Access Compliance Report

Public Rights-of-Way

(Curb Ramps)

Intersection ID: 10019944	Main Street: ARDREY_KELL_RD	Cross Street: N/A	Location: N
ADA ID: 83F839C3EA63	Ramp Type: Perp	Initial Pass/Fail: Fail	Overall Compliance: No
			Severity Score: 13.75

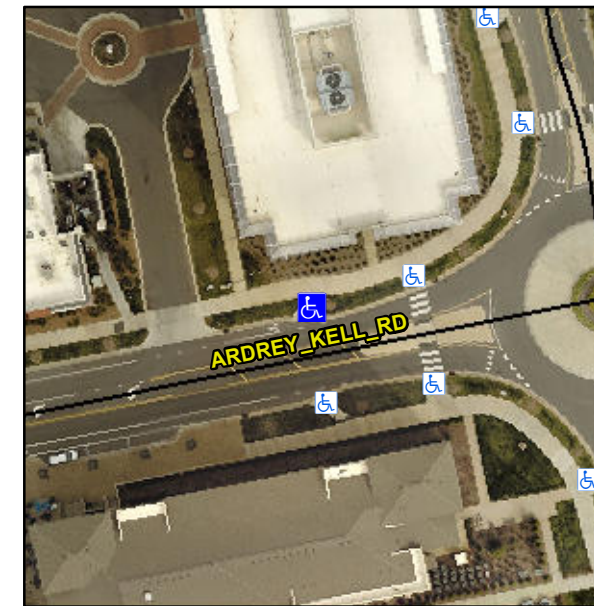
R304.2.2, R304.5.3

Compliance	Description	Data	Compliance	Description	Data
N/A	Ramp Length (in)	125.0	No	Ramp Slope (%)	8.6
Yes	Ramp Width (in)	72.0	No	Ramp XSlope (%)	2.4
N/A	Flare Type LT	N/A	N/A	Flare Type RT	N/A
N/A	Flare Slope LT (%)	N/A	N/A	Flare Slope RT (%)	N/A
N/A	Flare Traversable LT?	N/A	N/A	Flare Traversable RT?	N/A
N/A	Landing Length (in)	N/A	N/A	DWS Provided?	N/A
N/A	Landing Width (in)	N/A	N/A	DWS Contrast?	N/A
N/A	Landing Slope (%)	N/A	N/A	DWS Length (in)	N/A
N/A	Landing X Slope (%)	N/A	N/A	DWS Full Width?	N/A
N/A	Landing Curb? (Y/N)	N/A	N/A	DWS Offset (in)	N/A
N/A	Shared Landing?	N/A			
N/A	Gutter Ponding?	N/A	N/A	Gutter Slope (%)	N/A
N/A	Gutter Lip Ht (in)	N/A	N/A	Gutter X Slope (%)	N/A
N/A	Painted X Walk1?	No	N/A	Painted X Walk2?	N/A
	X Walk 1 Direction	To S		X Walk 2 Direction	N/A
N/A	X Walk 1 Width (in)	N/A	N/A	X Walk 2 Width (in)	N/A
	X Walk 1 Slope (%)	3.6		X Walk 2 Slope (%)	N/A
	X Walk 1 X Slope (%)	0.9		X Walk 2 X Slope (%)	N/A

Remove & Replace Entire Ramp.
